## **City of Keene Planning Board**

### **AGENDA**

**Monday, November 25, 2024      6:30 PM      City Hall, 2<sup>nd</sup> Floor Council Chambers**

- a. **PB-2024-15 – Major Site Plan – Monadnock Conservancy, 0 Ashuelot St** - Applicant the Monadnock Conservancy, on behalf of owner JRR Properties LLC, proposes to construct a ~6,215-sf office building and make associated site improvements on the parcel at 0 Ashuelot St (TMP #567-001-000). The parcel is ~3.53-ac in size and is located in the Commerce District.

Fig 3: 0 East elevation facing Ashuelot St.

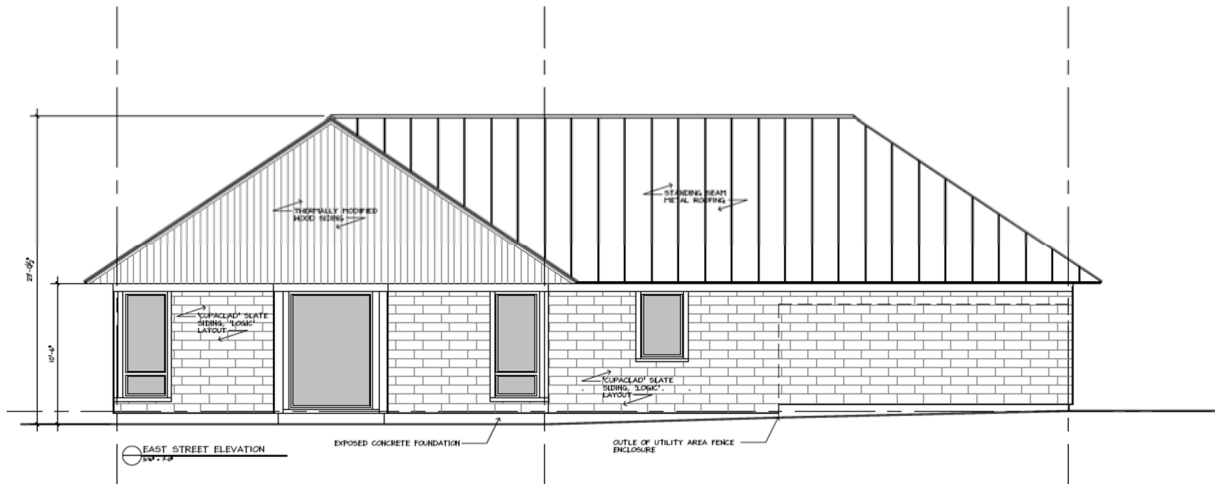
The east elevation (see Fig. 3) will face Ashuelot Street and depicts a mix of the three building façade materials, wood, slate, and metal. A wooden fence will also be located on this elevation to screen the proposed heat pumps from view of the public right-of-way.

The Board should consider the following standards as part of their review of the City's Architectural and Visual Appearance standards to determine if this standard has been met.

Figure 2. (Top) A snippet of the existing conditions plan for the Kia site. Figure 3. (Bottom) A snippet of the proposed conditions plan for the Kia site.

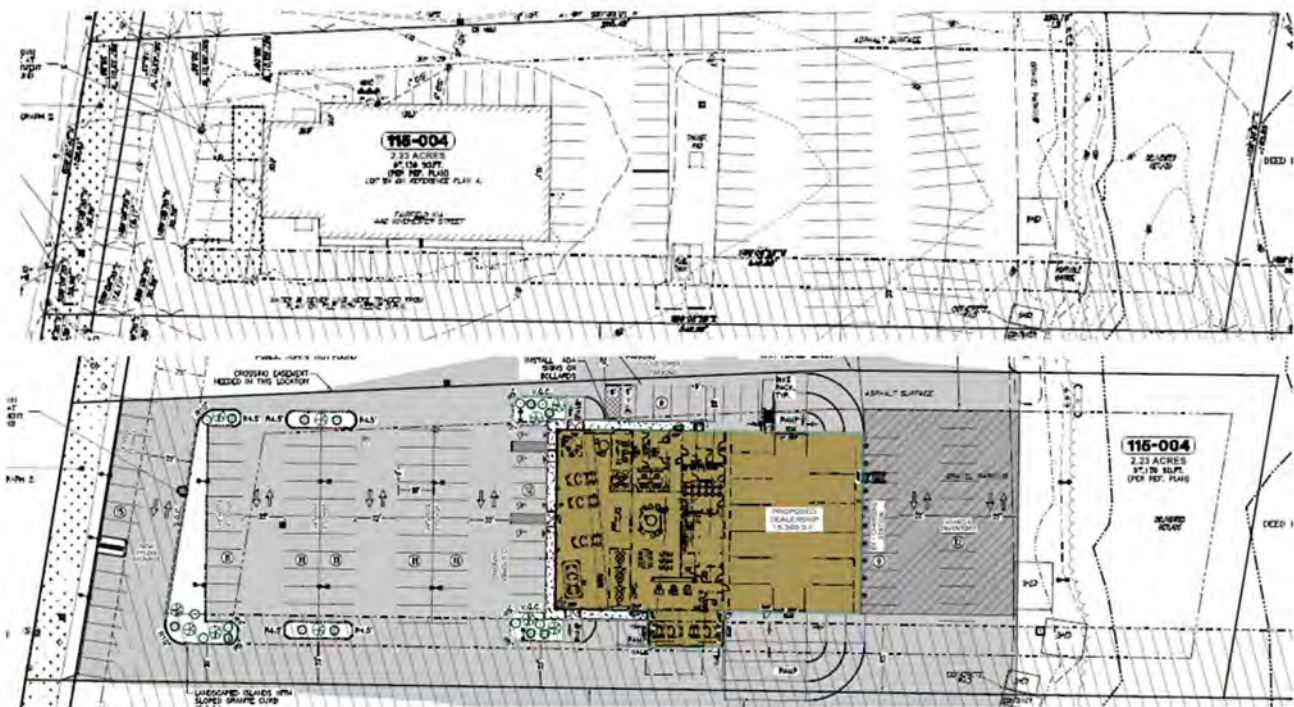
**Article 21.2 – Drainage & Stormwater Management:** The project narrative states that the applicant is proposing to use the existing drainage structures on the northern portion of the site that outlet into an existing drainage ditch near the northeastern corner of the site. Note #4 on the proposed conditions plan on Sheet 3 of the plan set shows that the amount of green space on the site will

During the review of this application, Zoning Staff requested that the applicant submit a detailed maintenance plan for the porous pavement proposed to be installed behind the new building on the rear portion of the site to ensure that it does not become impervious. The applicant has submitted an inspection and maintenance manual, which is included as an attachment to this staff report. The plan was reviewed by the City Engineer, who did not have any concerns. The second page of the manual recommends that inspections be performed every couple of weeks and after large storm events within the first year following construction to ensure that the site and slopes remain stabilized.

Planning Staff recommend that the Board include a condition of approval that all inspection reports be submitted to the Community Development Department for review and approval by the City Engineer's Office one year after the completion of construction. To ensure that these inspections are completed, Planning Staff also recommend that the Board require the submittal of a security to cover the cost of performing all inspections during the course of this year as a condition of approval. In addition, staff recommend that the submittal of an annual maintenance report to the Community Development Department and the submittal of an updated grading plan with a note added stating that an annual inspection and maintenance report for the porous pavement on the rear portion of the site shall be submitted to the Community Development Department be included as conditions of approval. This standard appears to be met.
